ADDENDUM NO. 4

PROJECT NAME: UNL Devaney Sports Center Improvements
UNL PROJECT NUMBER: C100P098

DATE OF ISSUANCE: Wednesday, April 11, 2012

S121-A

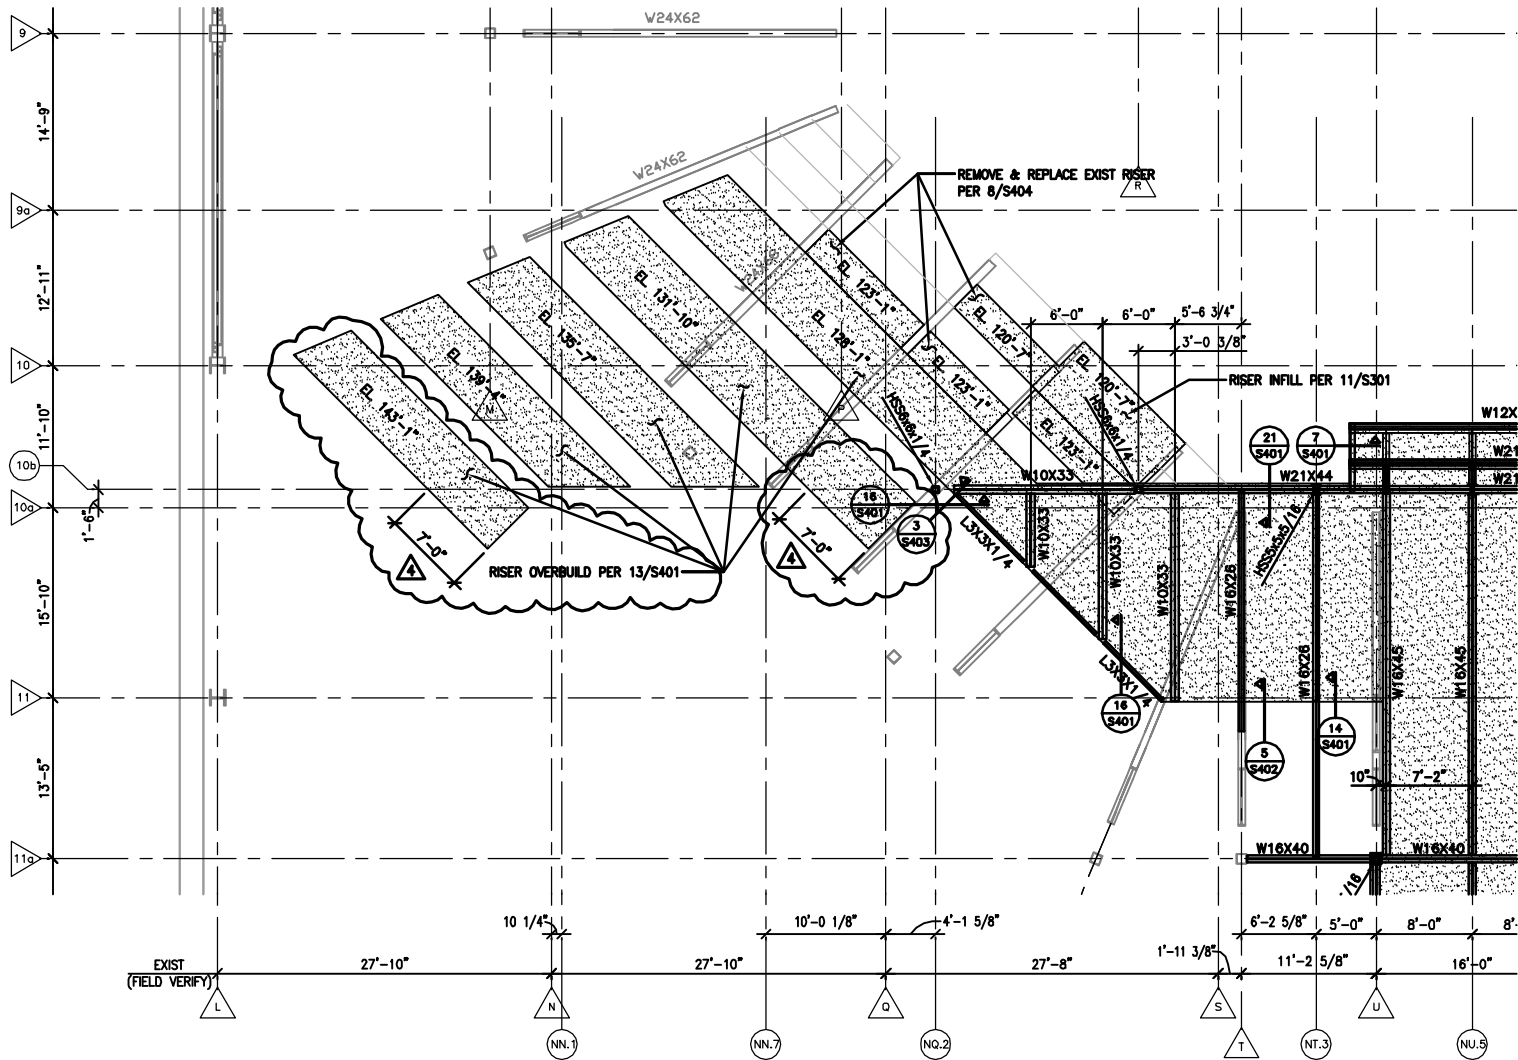
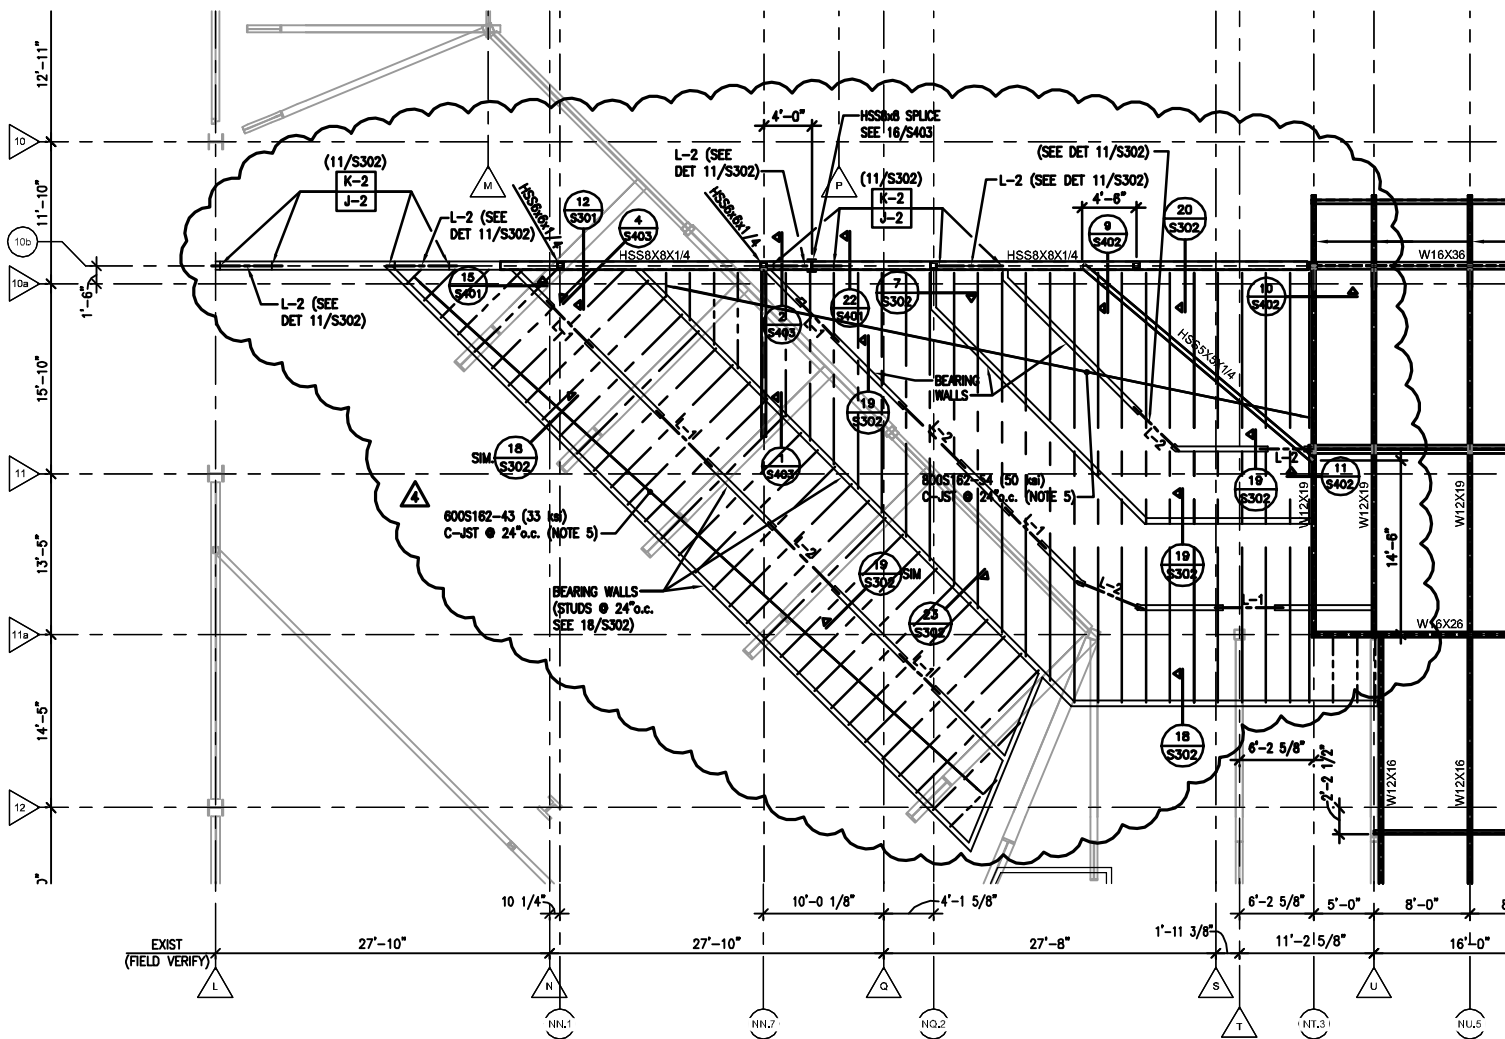
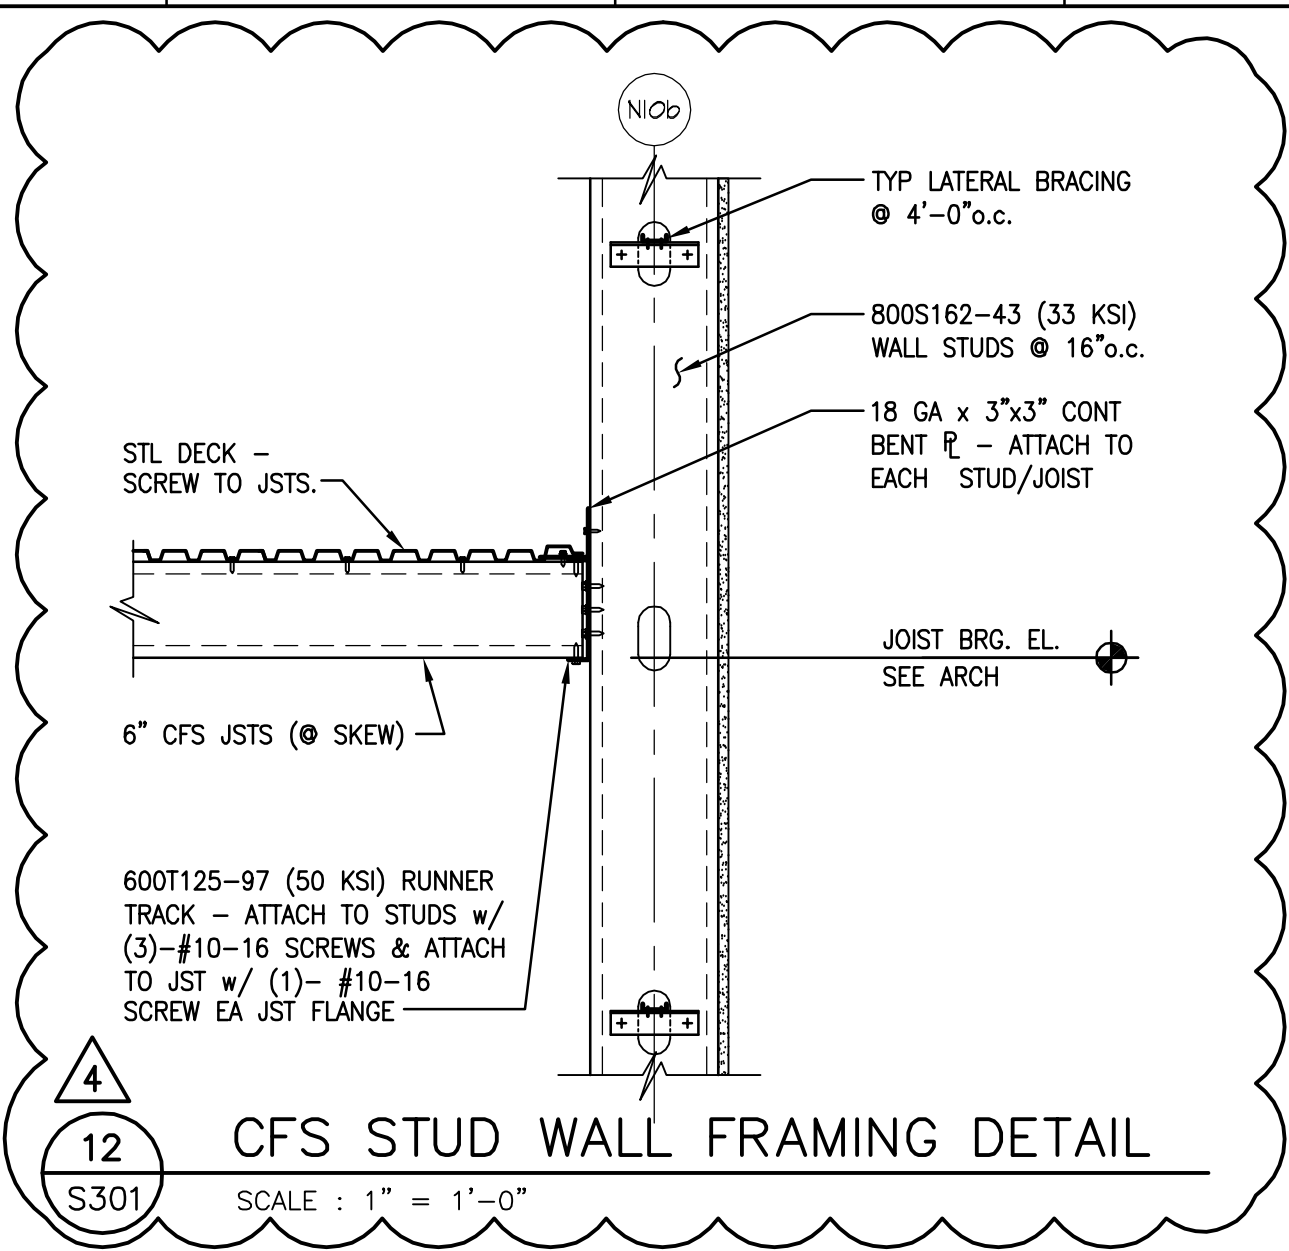
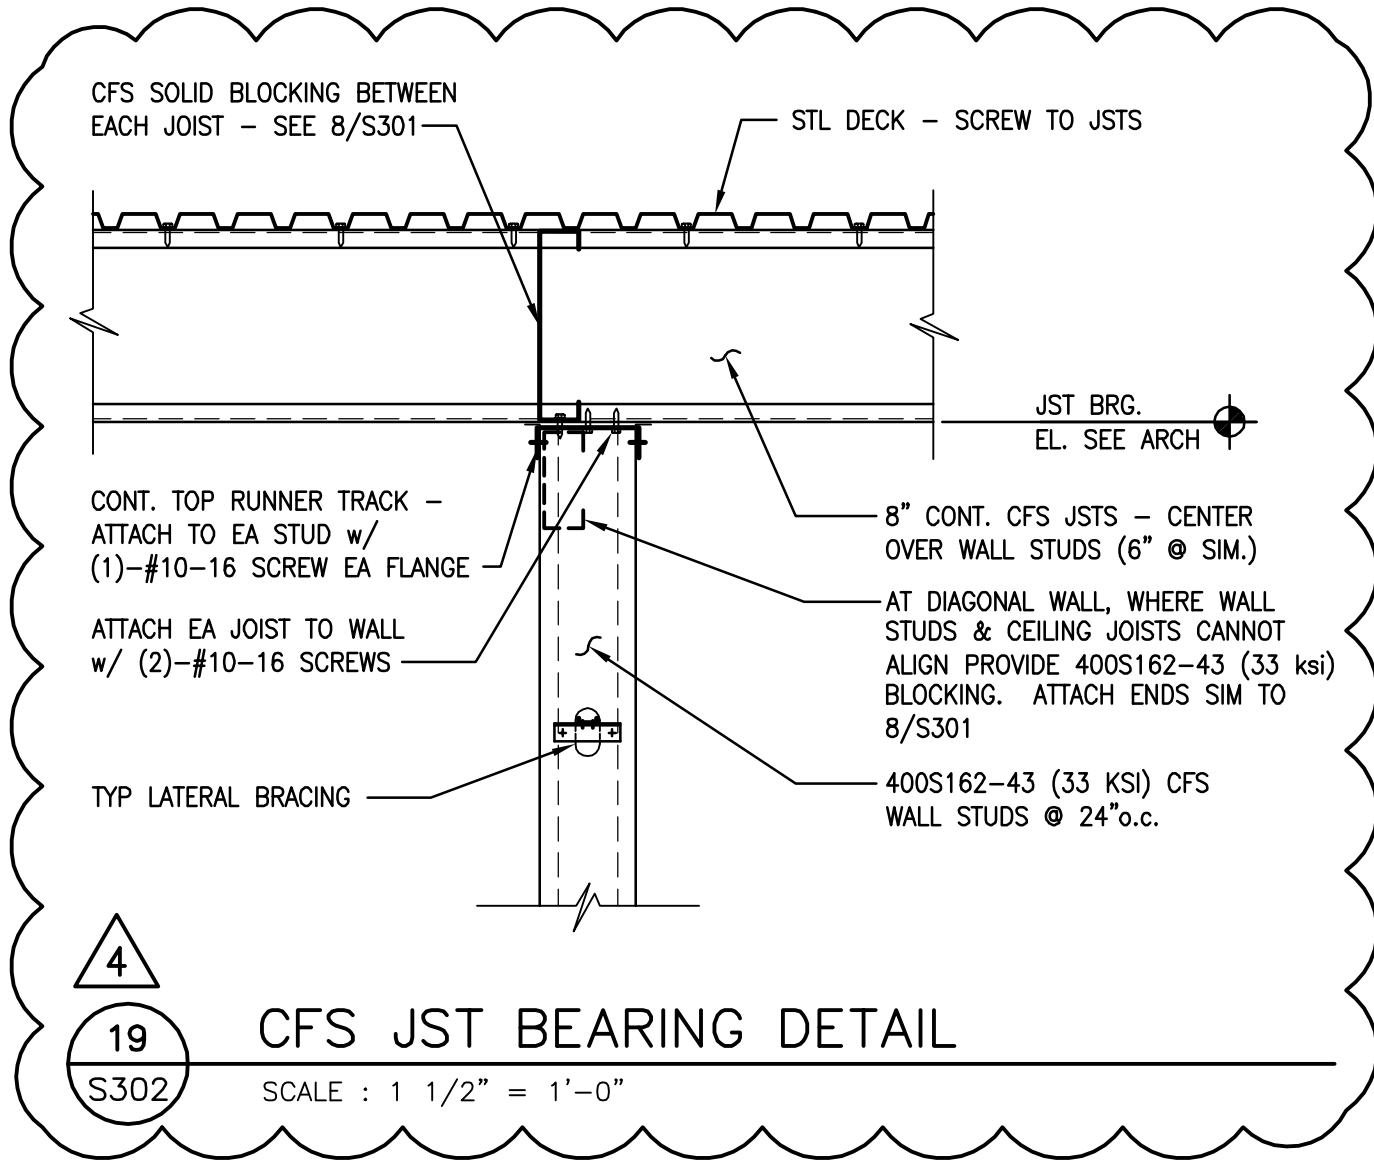
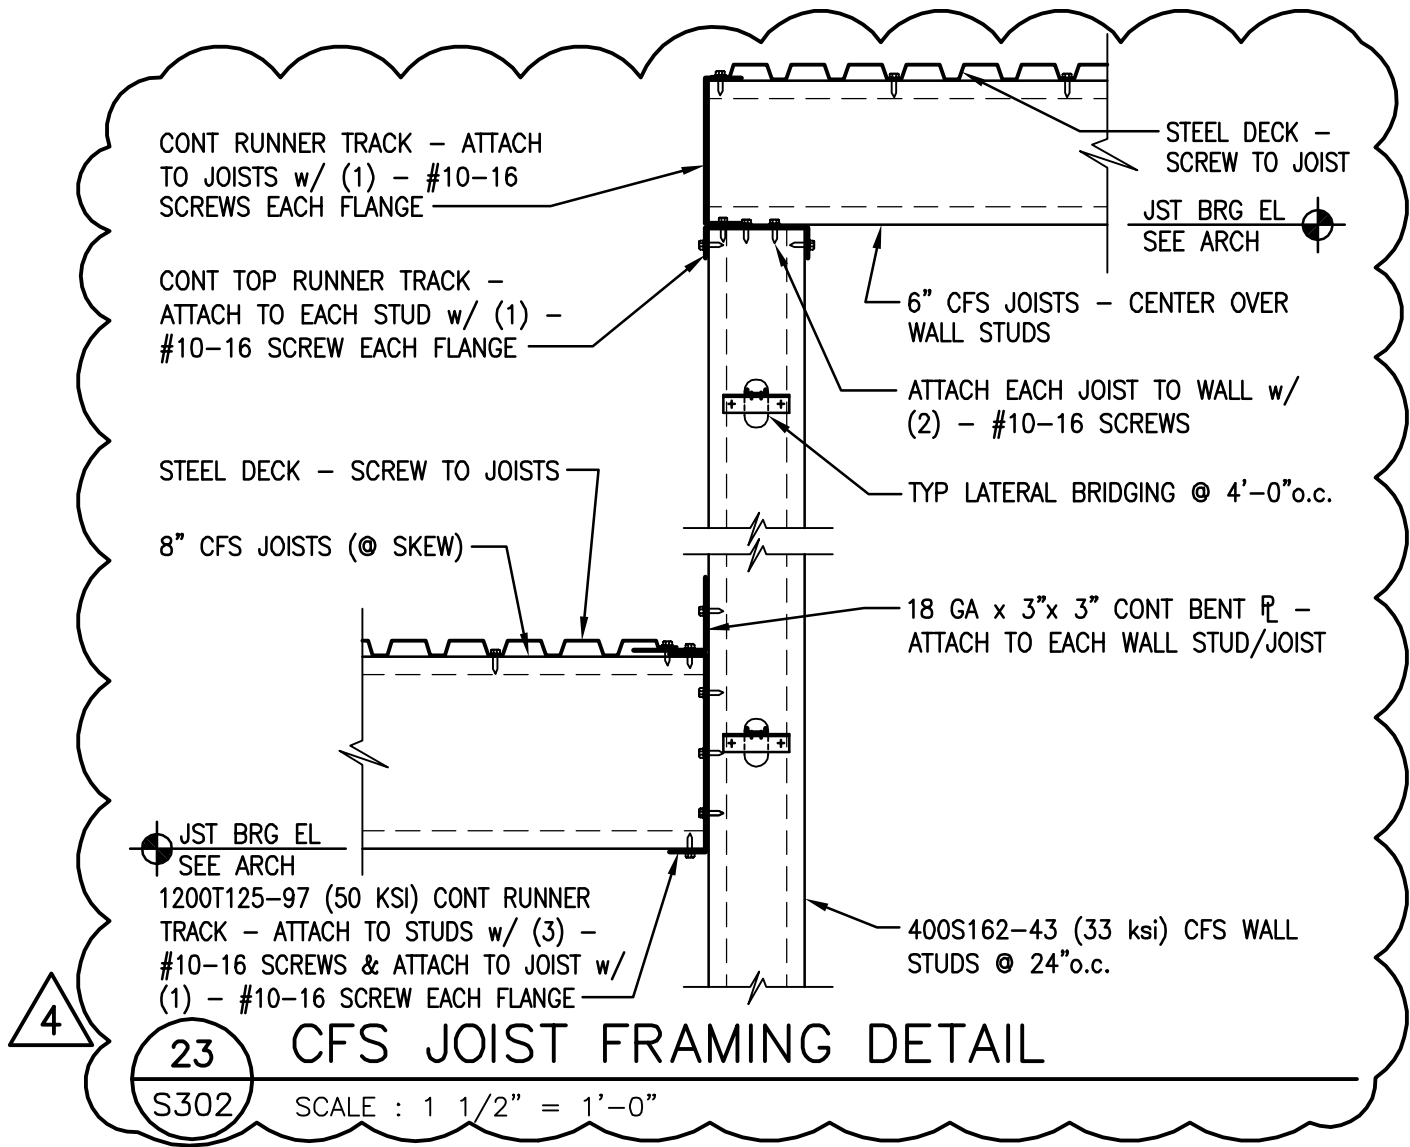
1. Refer to C11-Seating Level Plan. Add 2 enclosed storage rooms in the seat riser area behind the 'great wall'. (See the Attachment) See Mechanical / Electrical Addendum for the M/E work at these new rooms.
The Storage Room work also includes another row of riser overbuild as per Detail 13/S401 with a wall and counter per Detail A1/A602.
The work also includes a stair and landing at Door 430.2 constructed as similar to Detail 7/S402. This landing and stair is also to be constructed at the east side of the 'great wall' at Door 430.1
